RE: 22-125120-PLN  
Reid Saunders Association  
3985 Lindburg Road SE  
Salem, OR 97302

We wish to express our appreciation for your timely review of the Construction Documents for Reid Saunders Association. Attached is your Plan Review Comments, and following are our proposed responses.

REID SAUNDERS ASSOCIATION  
PROJECT NUMBER: 2022.0003  
STATE OF OREGON 2022 STRUCTURAL SPECIALTY CODE, AMENDMENTS BASED ON 2021 IBC

FIRST FLOOR CODE PLAN

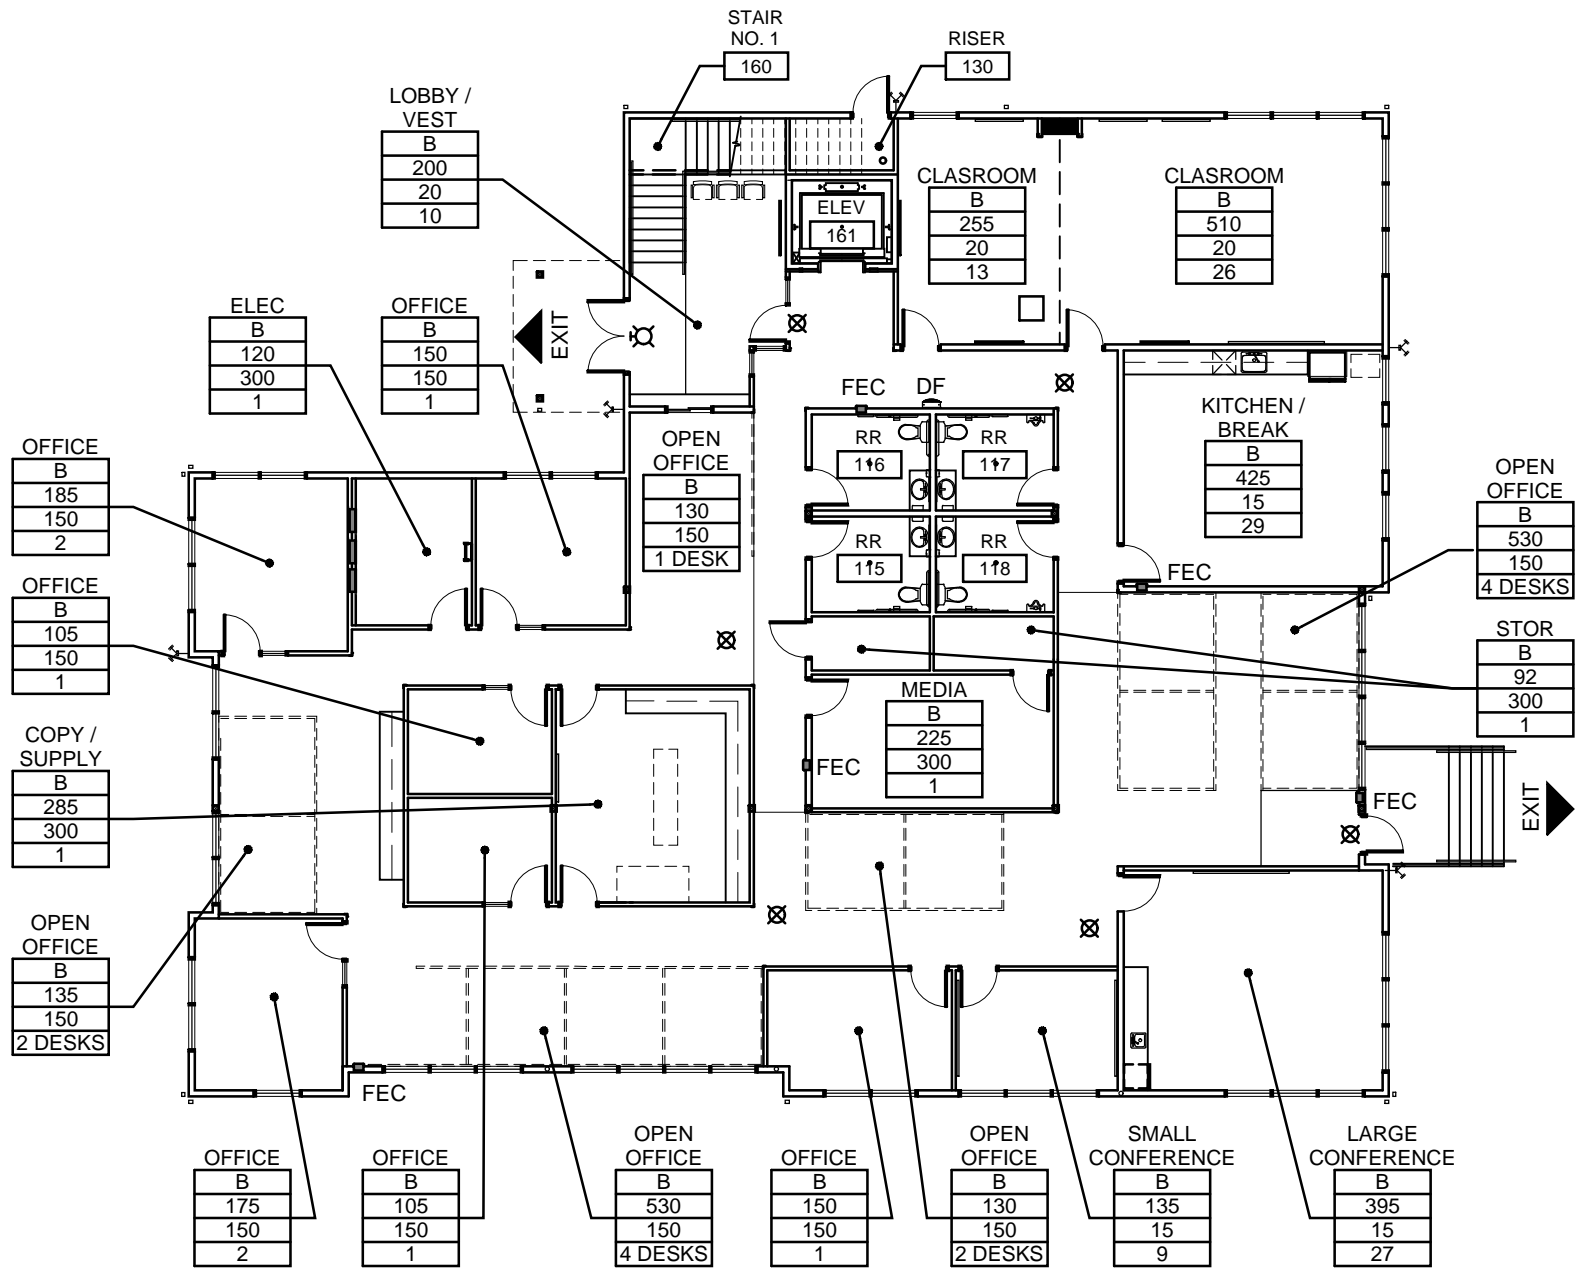
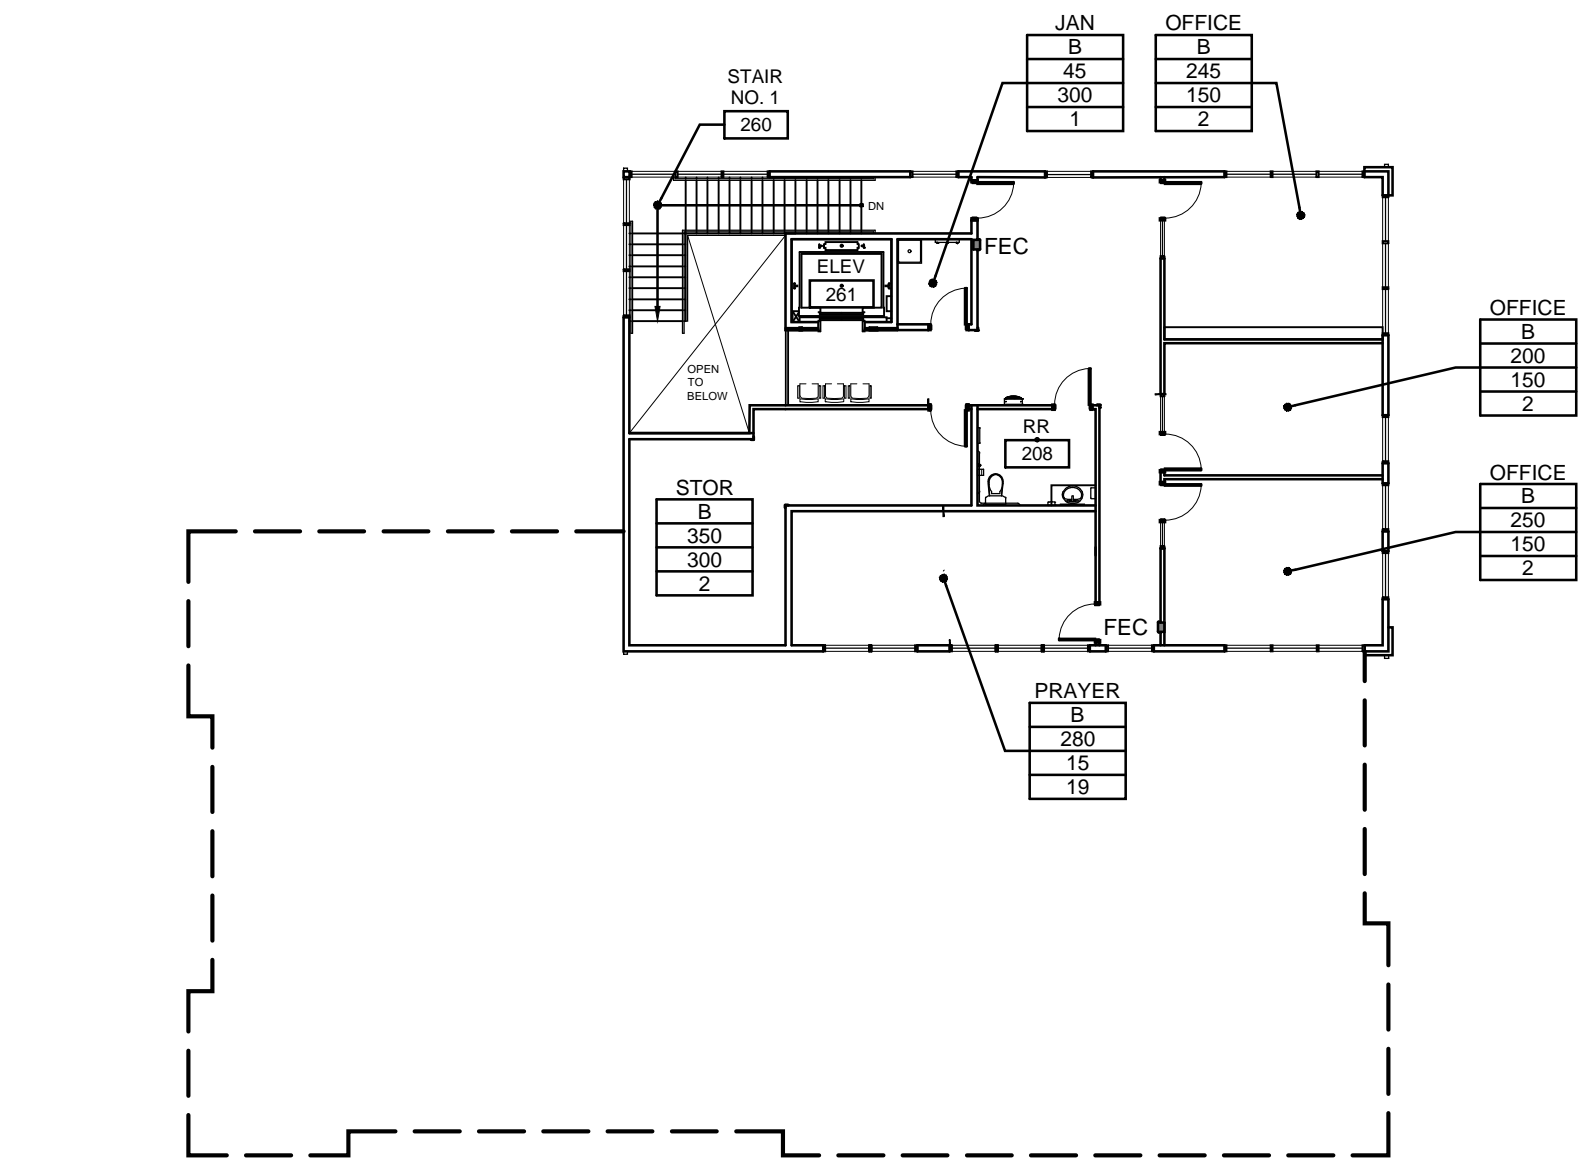
- iii. The site summary has been moved to the code sheet, A0.1, in preparation for Building Permit submission. See attached for the site summary.
- iv. The turnaround is now configured per Figure 806-9.
- v. Weather protection over the main entry is addressed above.
- vi. Repositioning the building due to the south utility easement puts us out of conformance for the southern setback. I revised the Class 2 Adjustment write-up to include this deficiency, refer to the attached.
- vii. A pedestrian crossing has been provided between the ADA stalls as requested.
- viii. The diagonal spaces have been marked as 'Compact'.
- ix. Window extensions (marked up on A3.1) is addressed above.

1 SITE PLAN  
SCALE: 1"=20'-0"

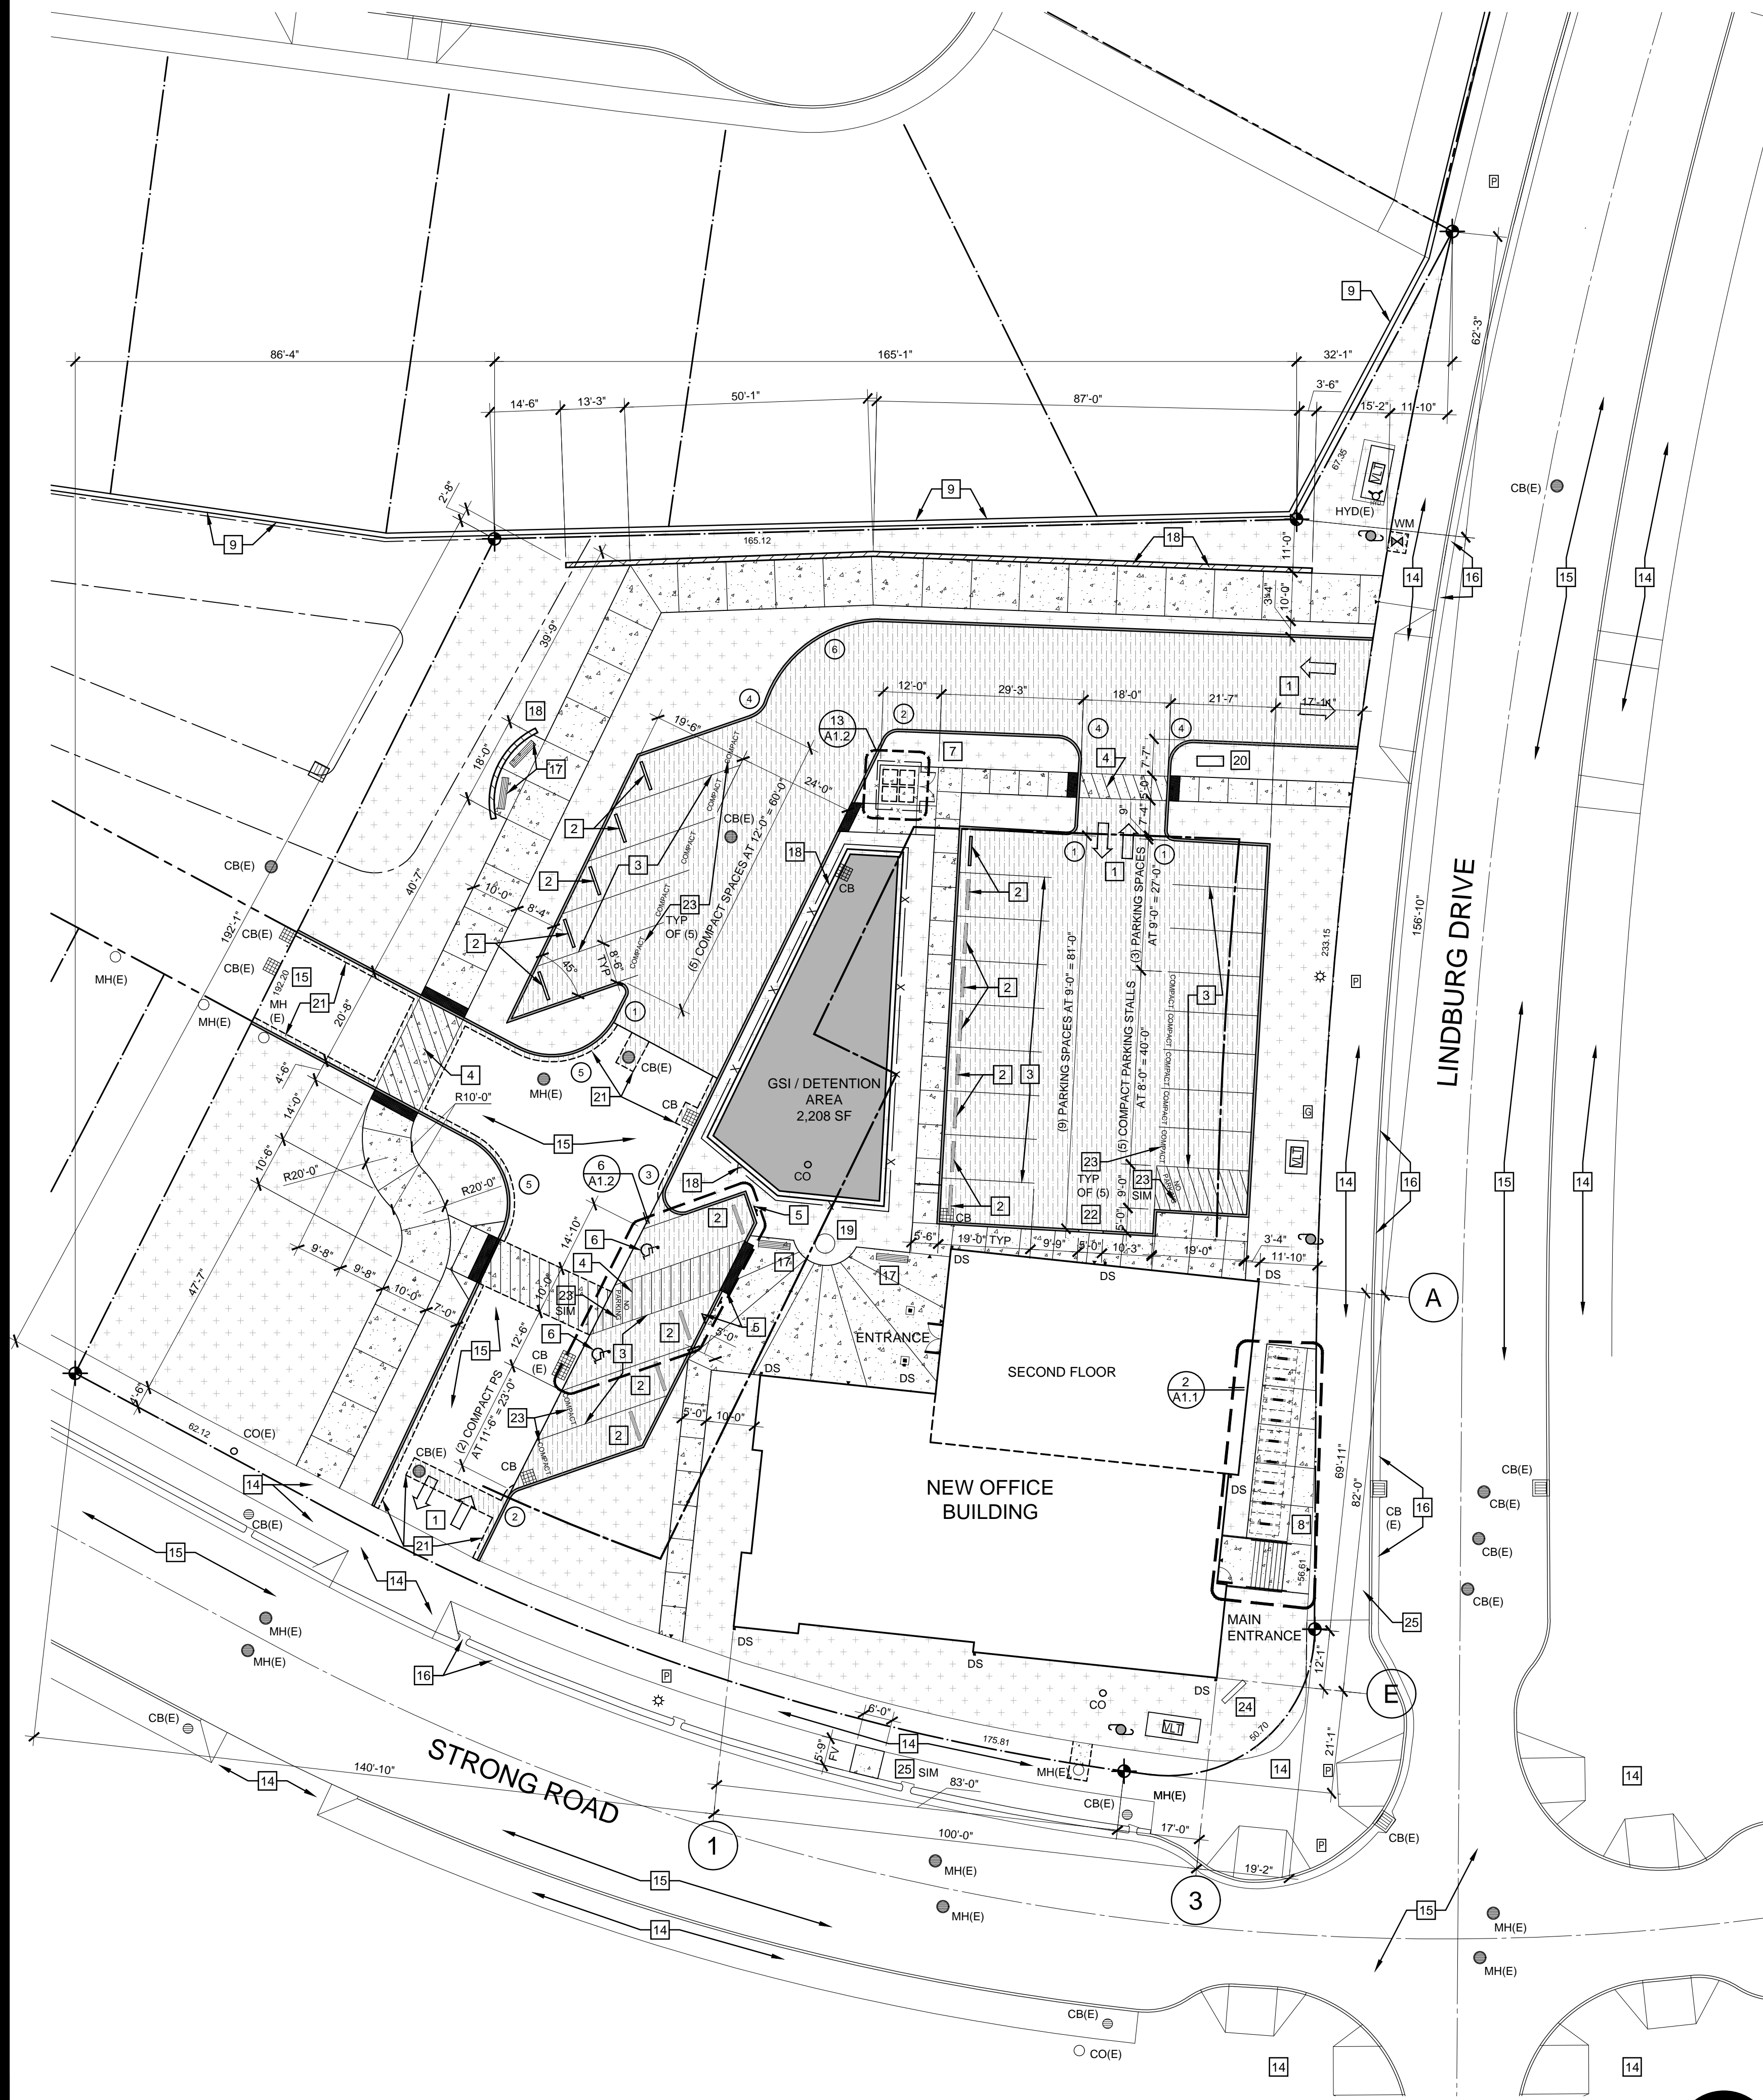
1. Site Plan:
  - a. The site plan has been revised to include the property line dimensions that reflect those on the plat. The dimensions shown on the plans are angled dimensions relative to construction and shall not match the linear dimension of the property.

4. Additional Comments on Plan:
  - a. The site plan on Sheet A1.1 has been updated to reflect the markups. See below additional comments and information.
